**ADDENDUM TO INVITATION FOR BIDS**  
**Bridgeville Elementary School District**  
**Proposition 39**  
**Heat Pump Installation, Phase II**  
**Bid No. 17-027**

**Addendum #1**  
**November 17, 2017**

**Revised Appendix 3:  
Base Bid and Additive Alternate Site Plan**

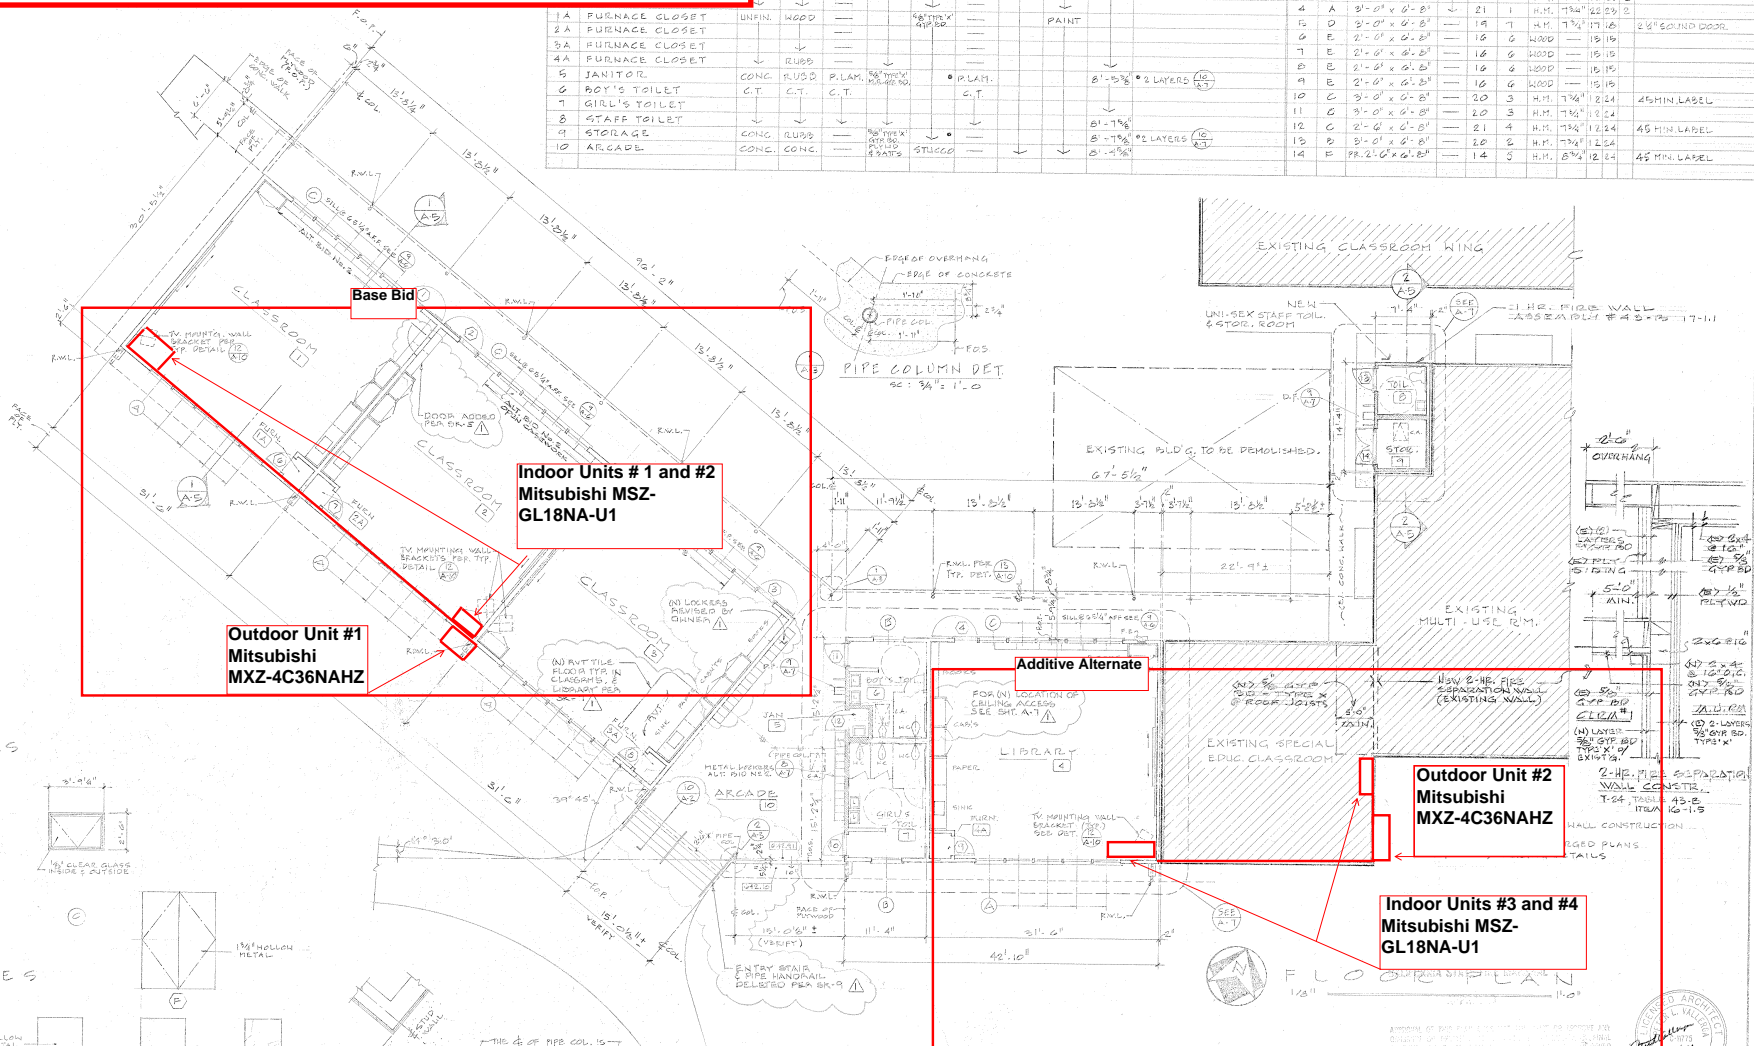
1. Bidders are to provide and install a chase or raceway to cover and protect refrigerant lines installed along the building exterior.
2. The location of the indoor mounted units has been revised. See updated Appendix 3 for new locations.
